CHANGE ORDER REQUEST FORM

PROJECT William Burgess Extension

No. 005

Plan Revision No. 02 reconfigured the drainage system leading into Pond D. The revision redirects water directly from structures S-75, S-76, S-78, S-80, and S-81 to the MES within the pond. This change eliminated a deep pipe run and resulted in cost savings for the County

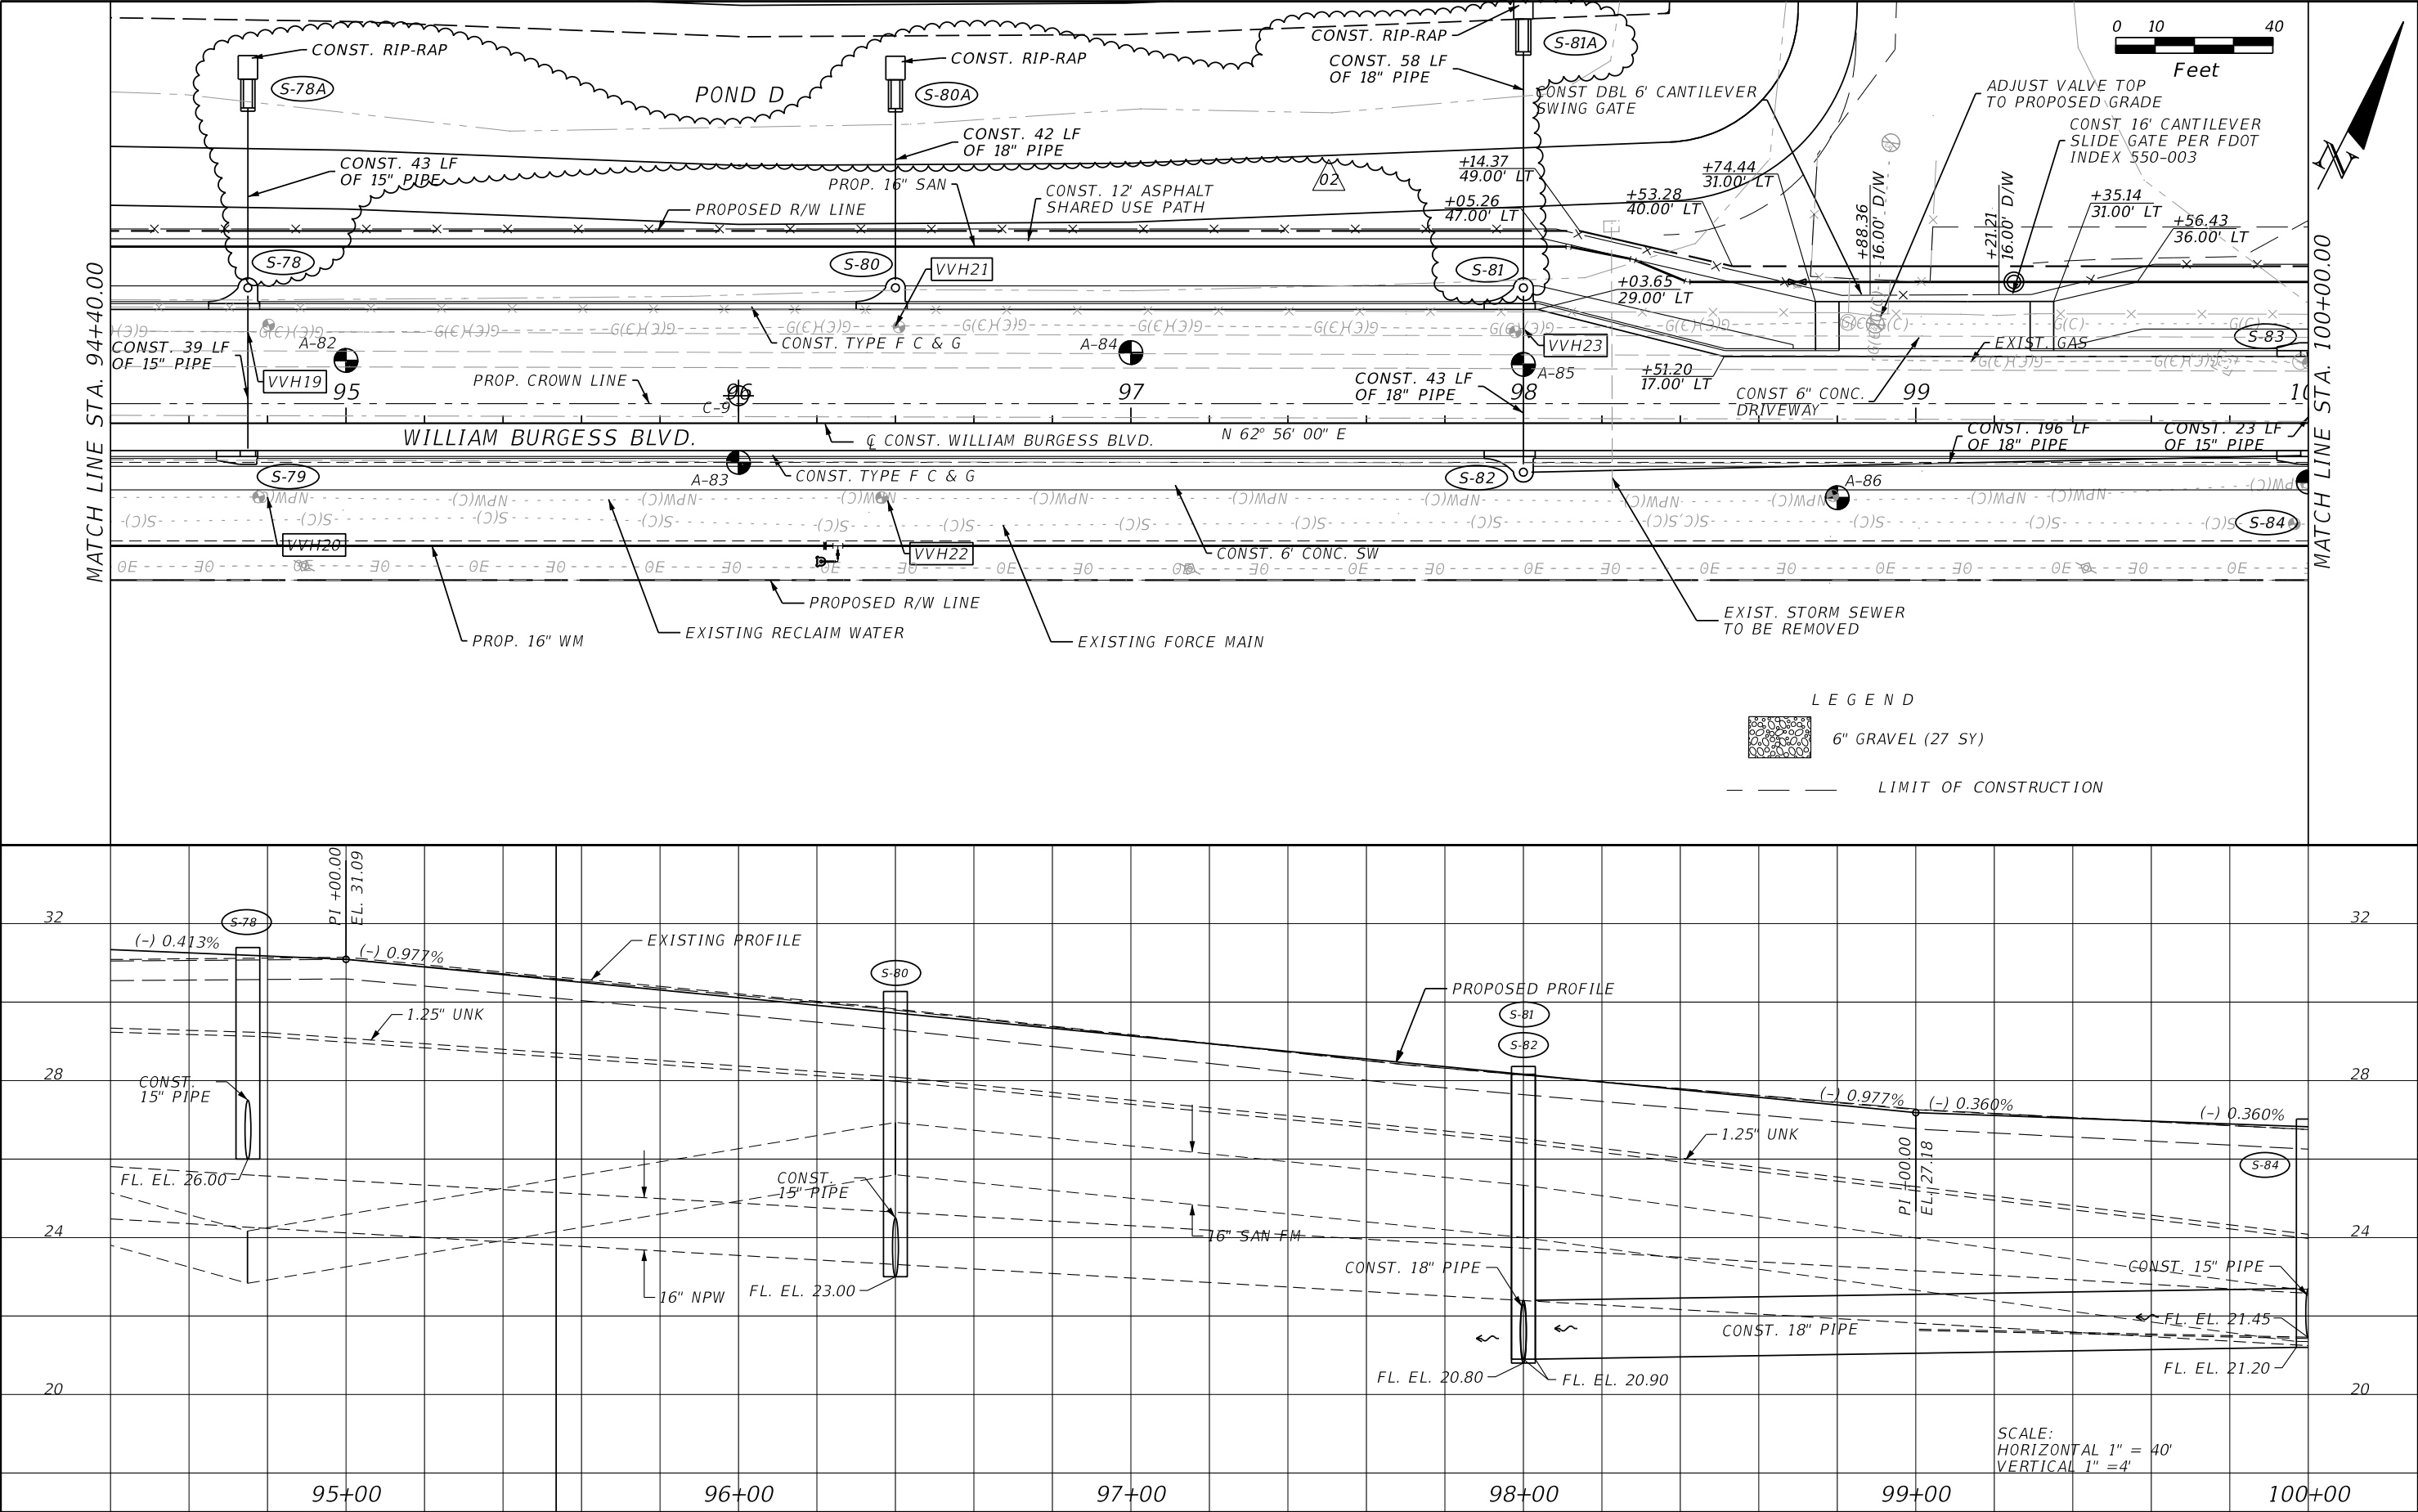
REVISIONS				PROJECT NO. / DASH NO.		PLAN AND PROFILE		SHEET NO.
REV	DATE	BY	DESCRIPTION					
02	1/13/25	RFH	STORM SEWER REVISED	DATE:	1/22/2025	B190839.00	WILLIAM BURGESS BLVD. EXTENSION NASSAU COUNTY FLORIDA	44
				DRAWN:	JD	This drawing was produced with computer aided drafting technology and is supported by electronic drawing files. Do not revise this drawing via manual drafting methods.		
				CHECKED:	RT			
				APPROVED:	RH

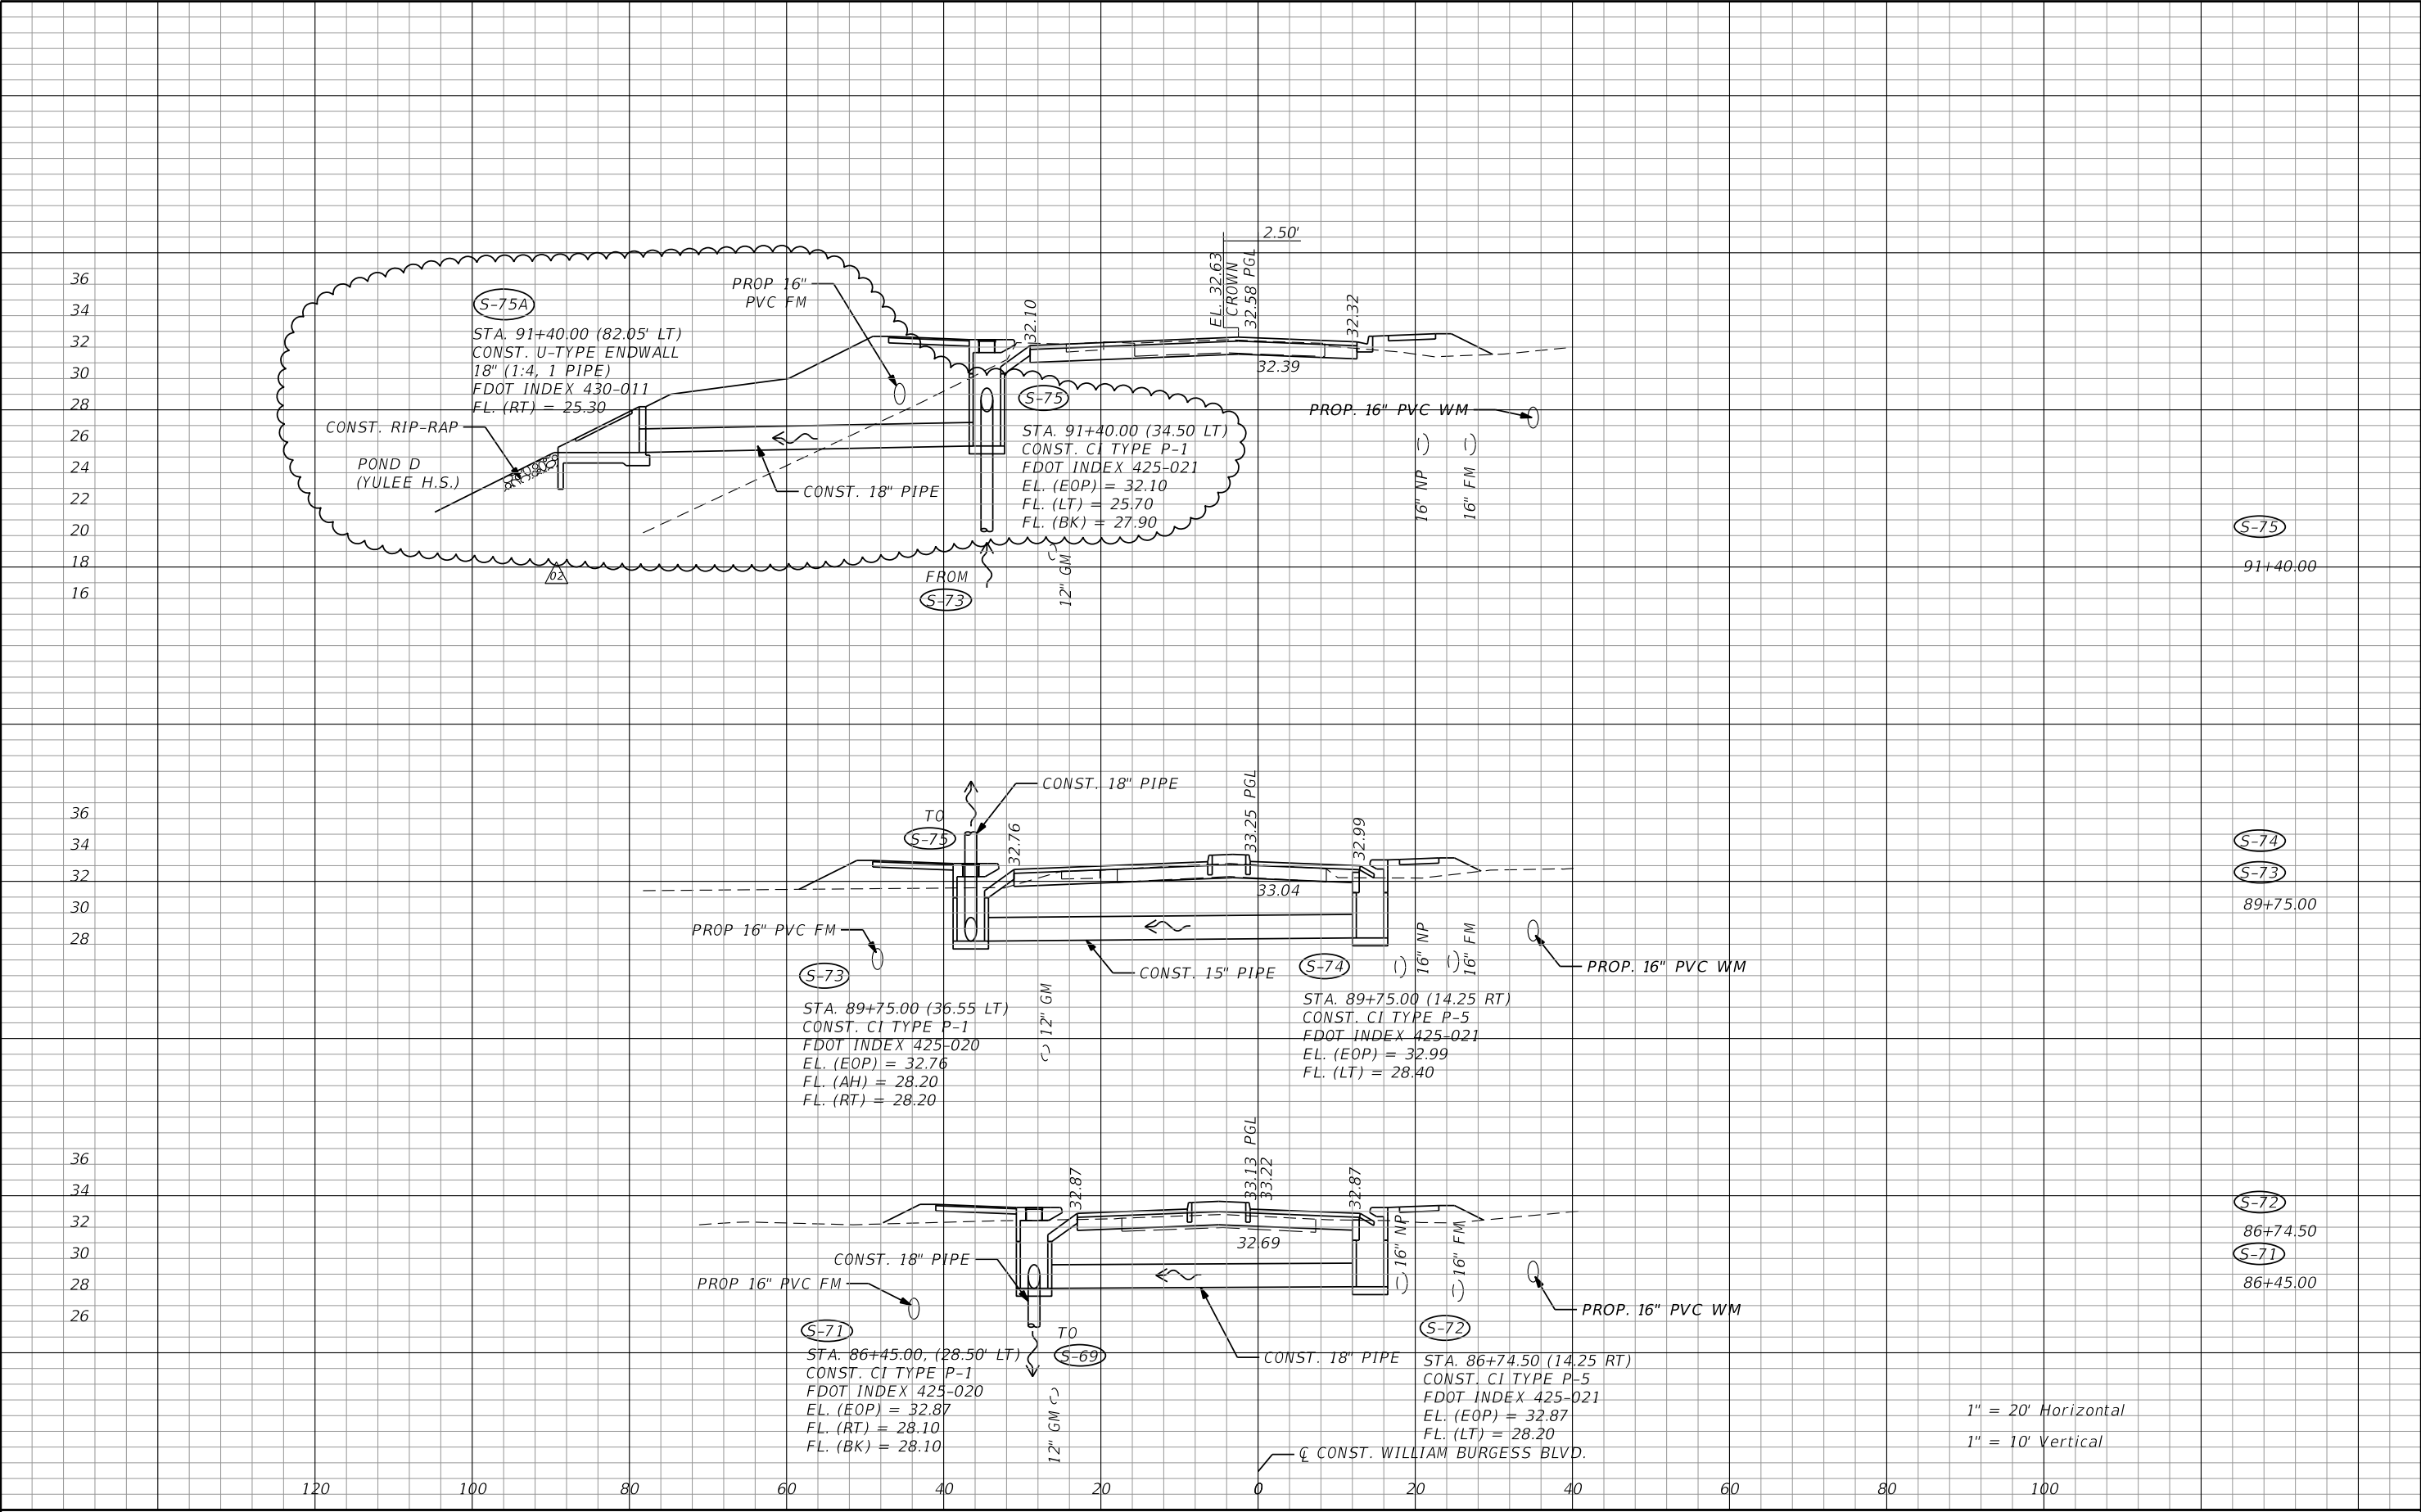
REVISIONS				 transforming ideas into reality® 12574 Flagler Center Blvd, Suite 202 Jacksonville, FL 32258 904.363.1110 Certificate of Authorization:EB9951	SCALE: AS SHOWN DATE: 1/15/2025 DRAWN: JD CHECKED: LP APPROVED: RH	PROJECT NO. / DASH NO. B190839.00	DRAINAGE STRUCTURES WILLIAM BURGESS BLVD. EXTENSION NASSAU COUNTY, FLORIDA	SHEET NO. 84
REV	DATE	BY	DESCRIPTION					
02	1/13/25	RFH	STORM SEWER ADJUSTMENT

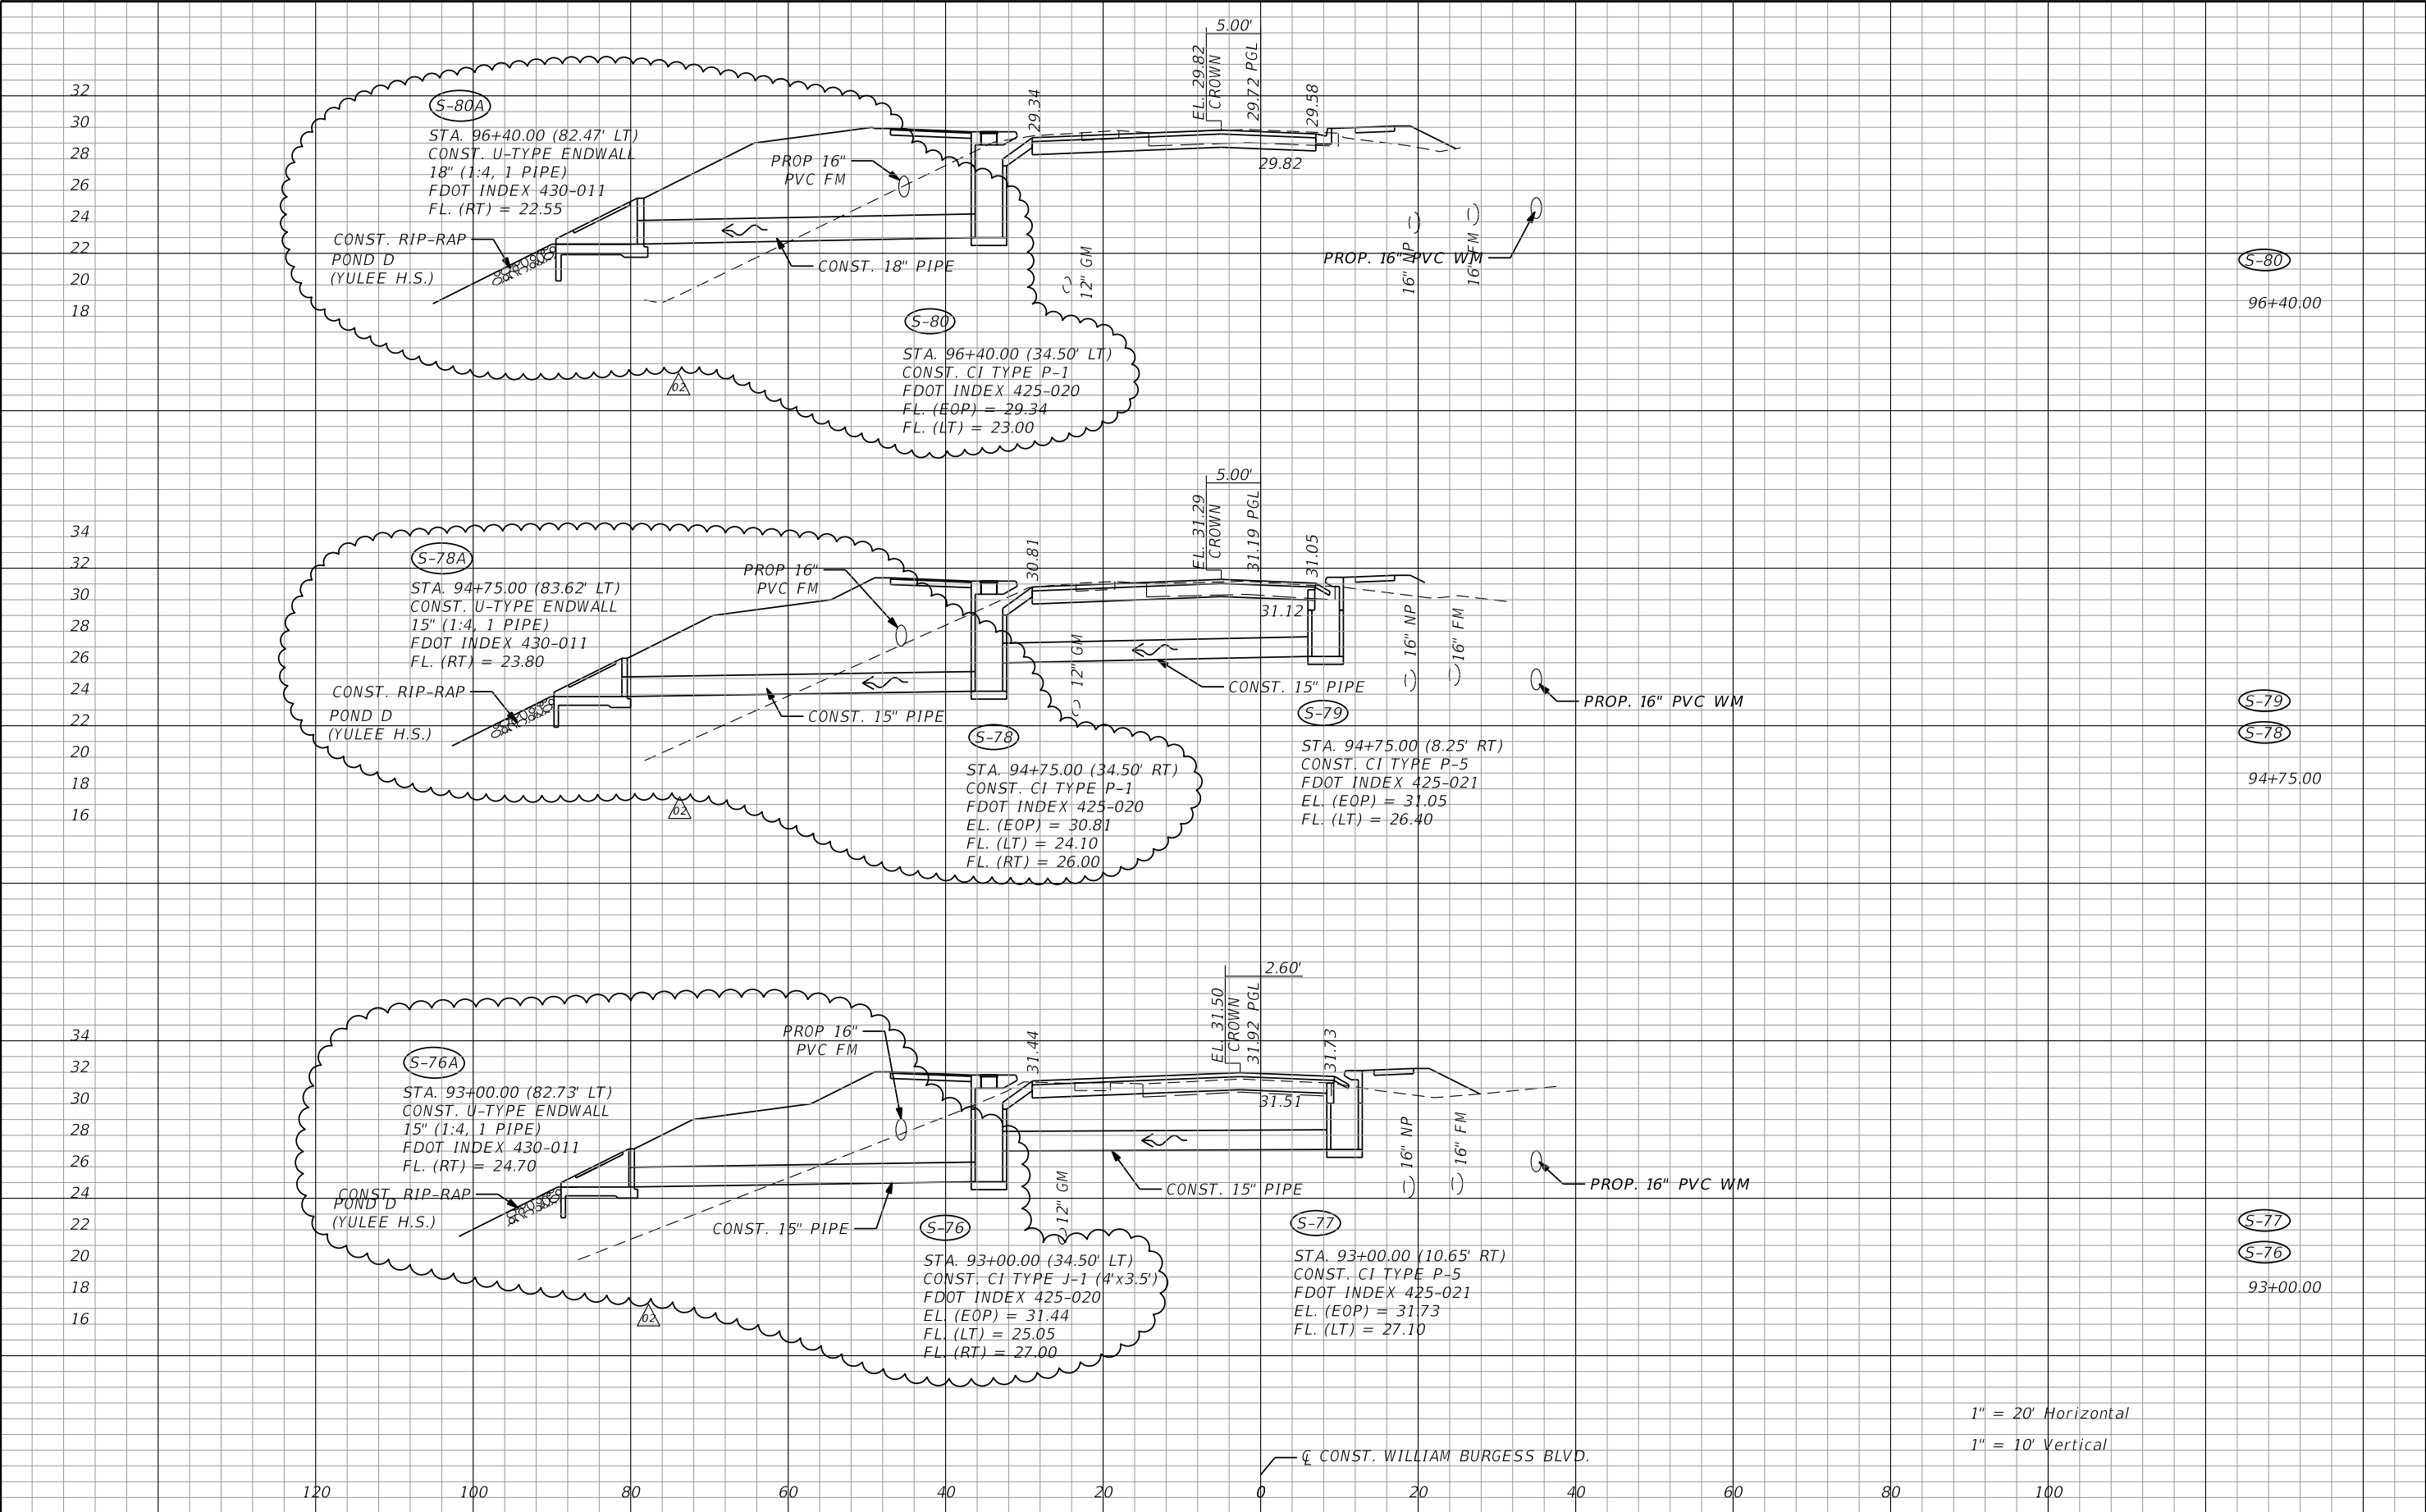
REVISIONS			
REV	DATE	BY	DESCRIPTION
02	1/13/25	RFH	STORM SEWER ADJUSTMENT
